MISSISSIPPI DEPARTMENT OF TRANSPORTATION

SECTION 904 - NOTICE TO BIDDERS NO. 3502

PROJECT: BR-0009-01(132)/107176301 - WILKINSON

ADDENDUM

WORKING NUMBER
TS-2
SHEET NUMBER
5

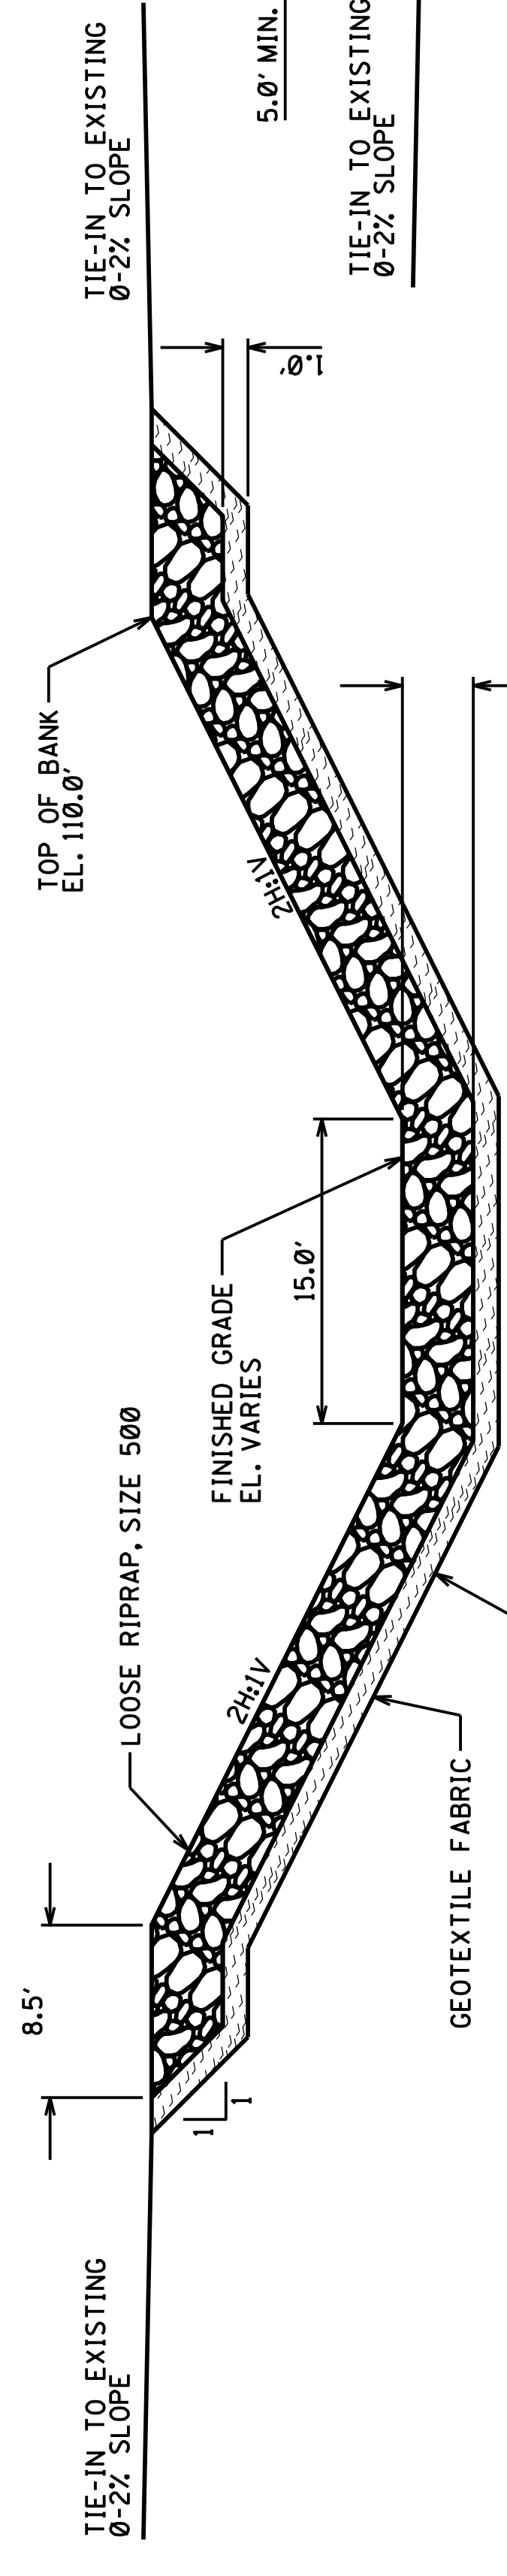
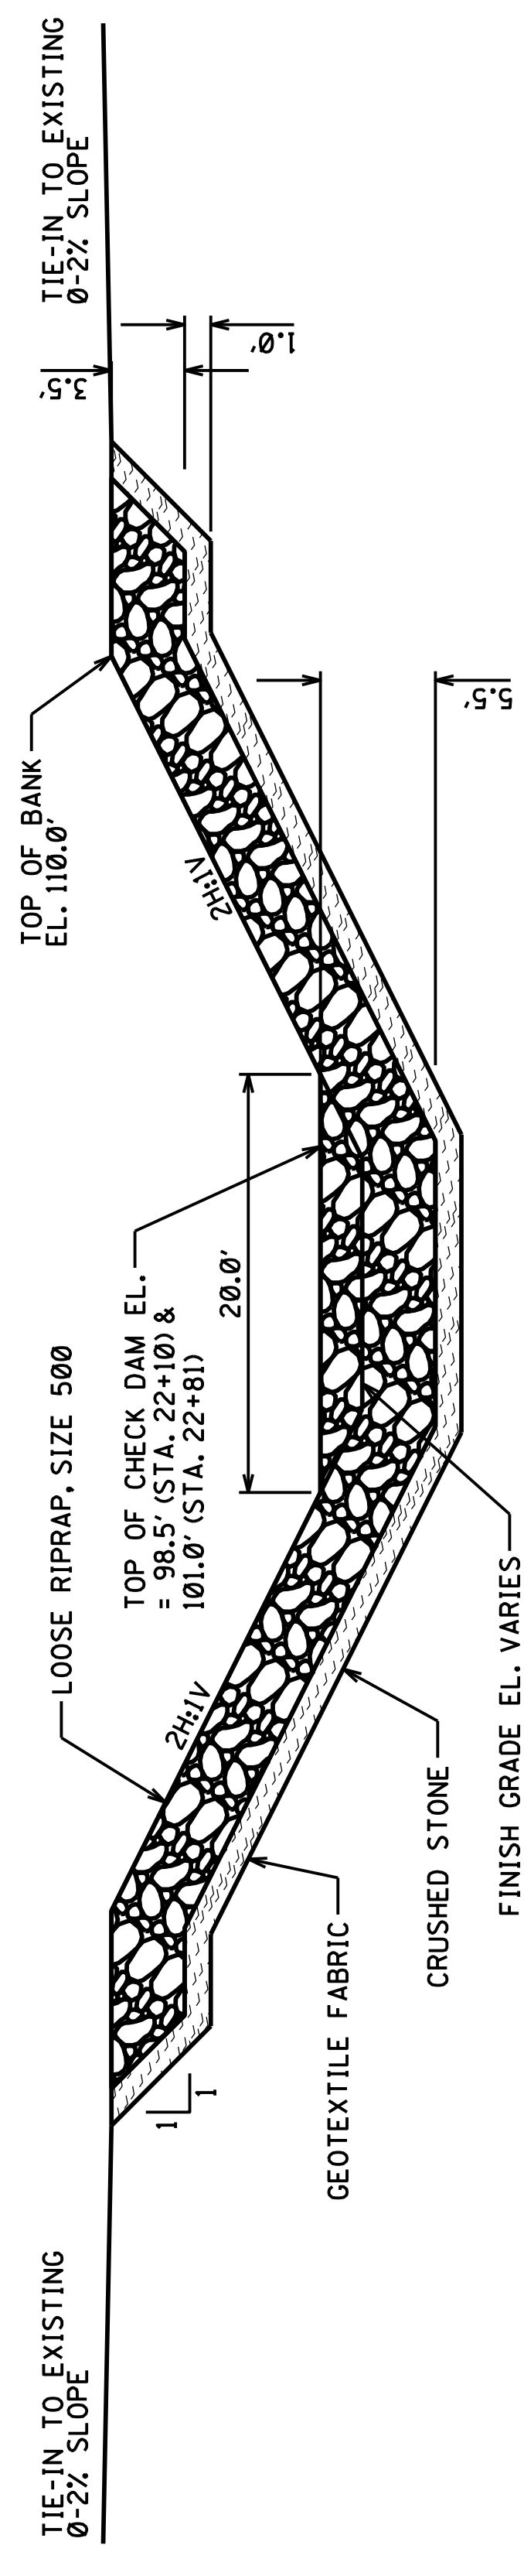
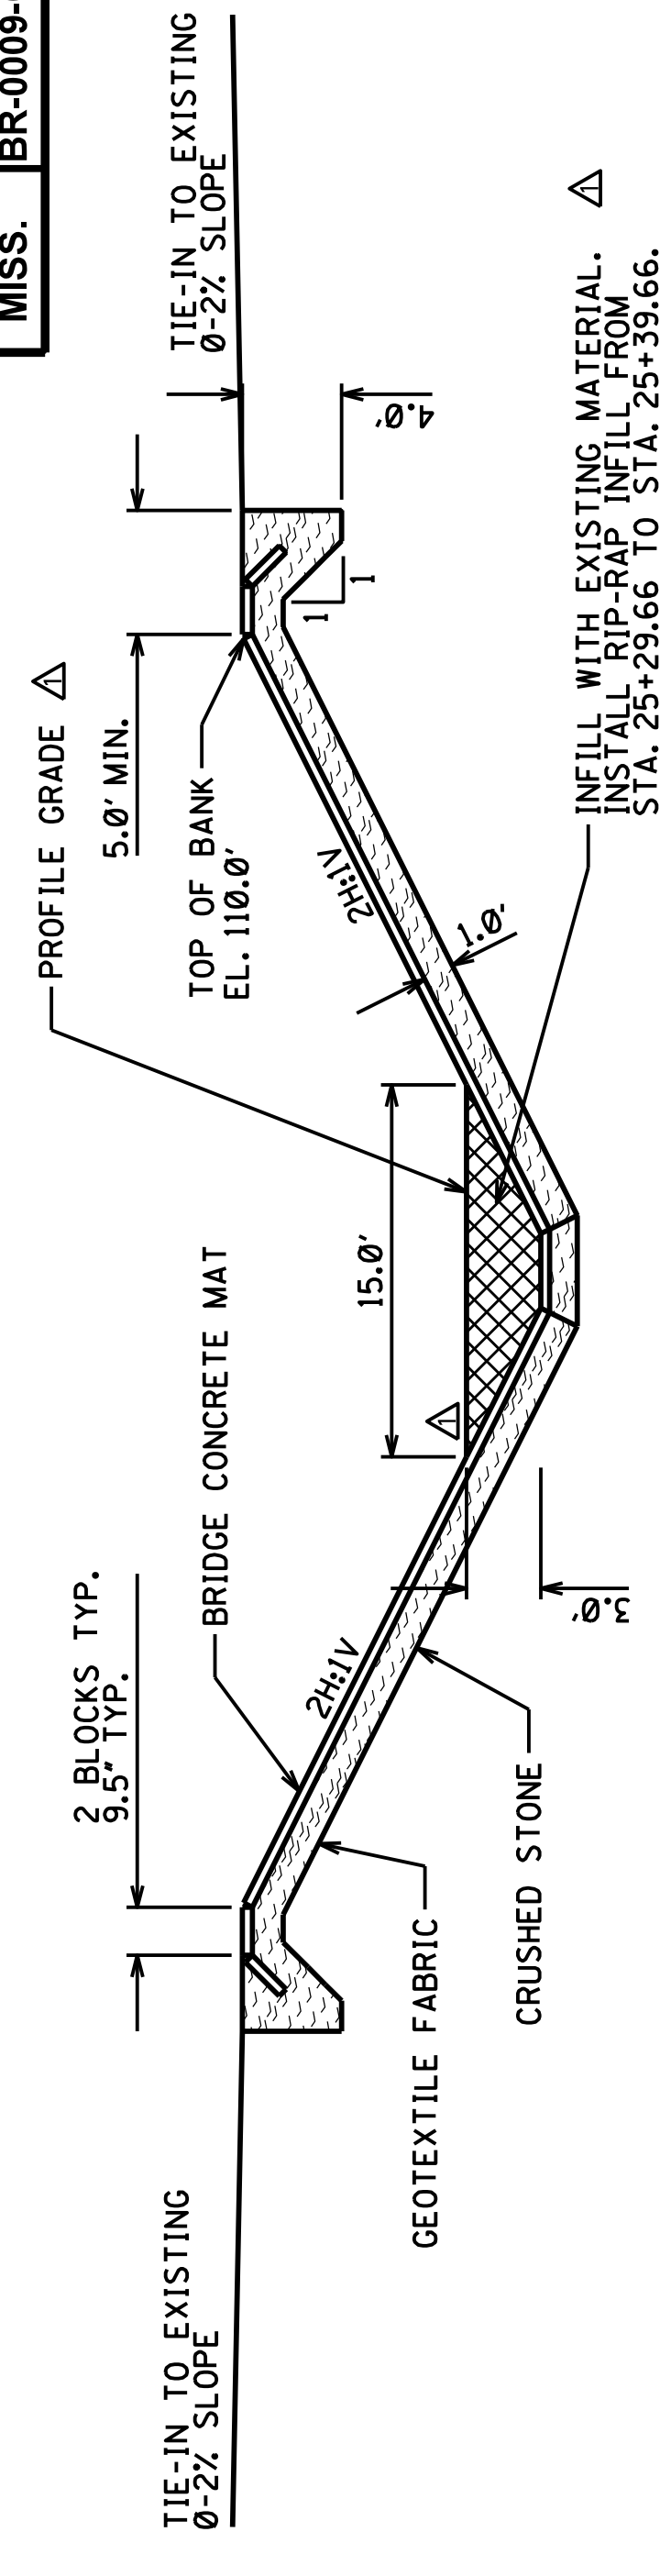
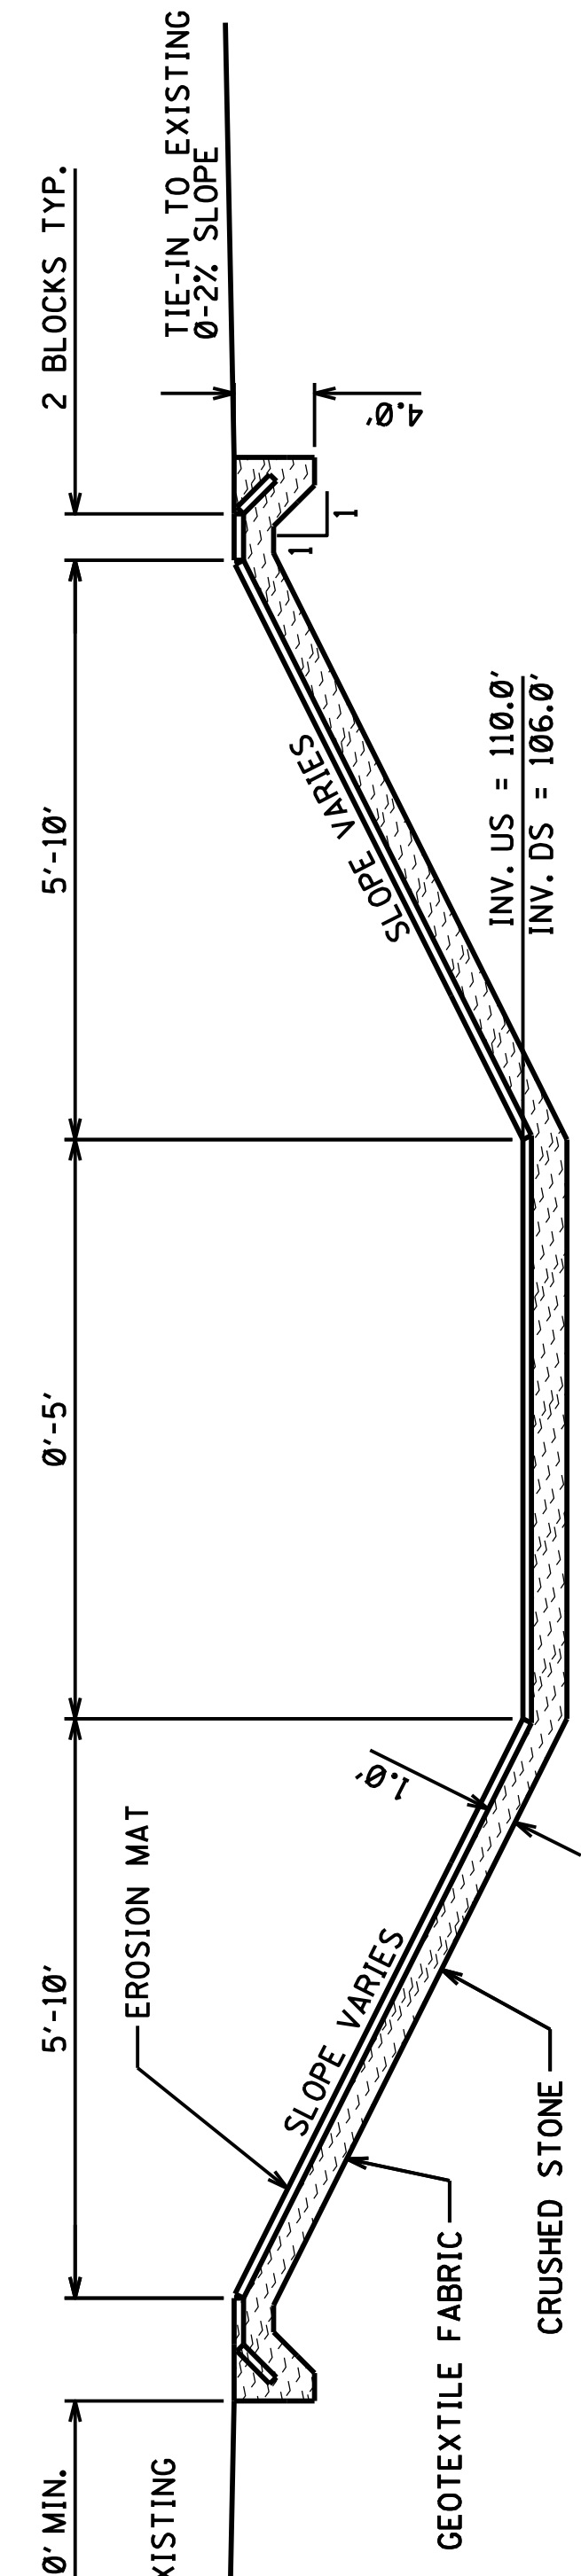
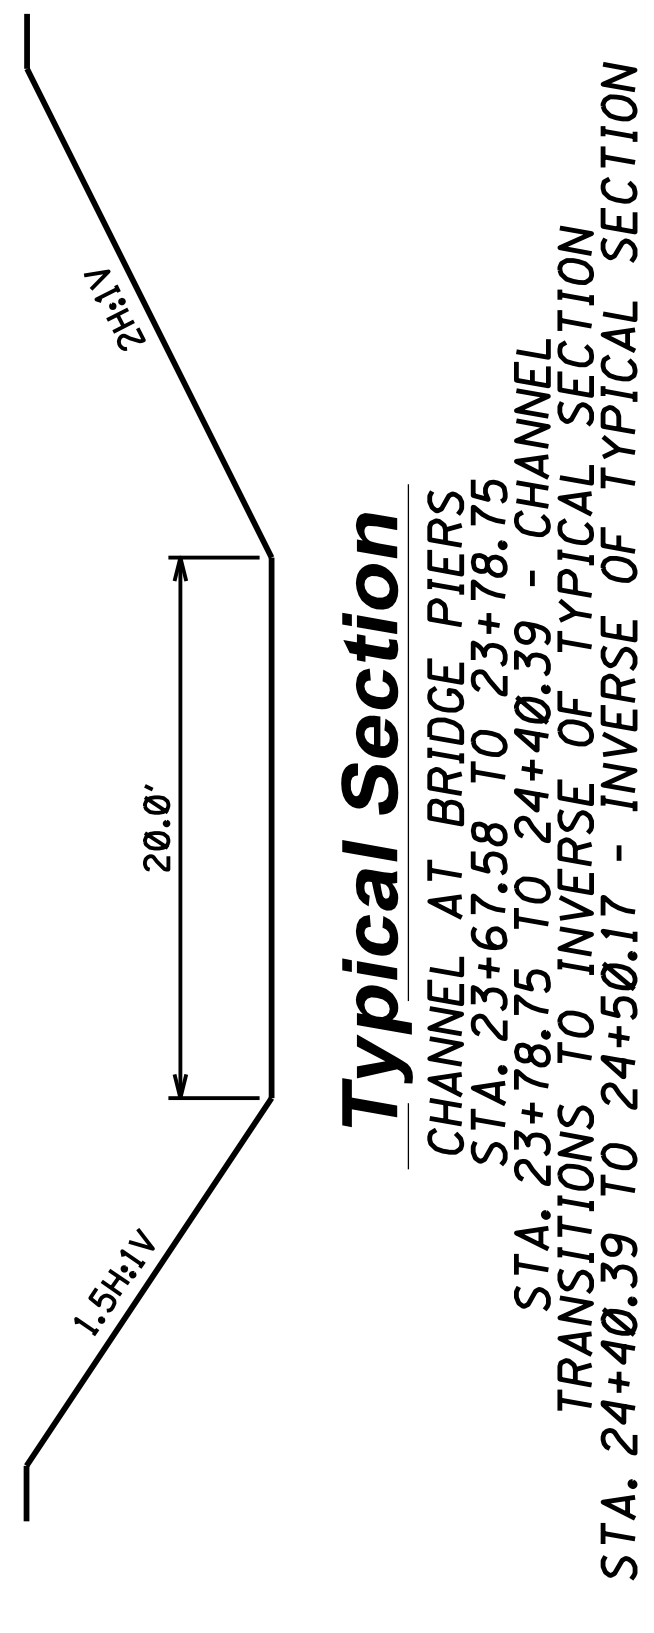
ADDENDUM
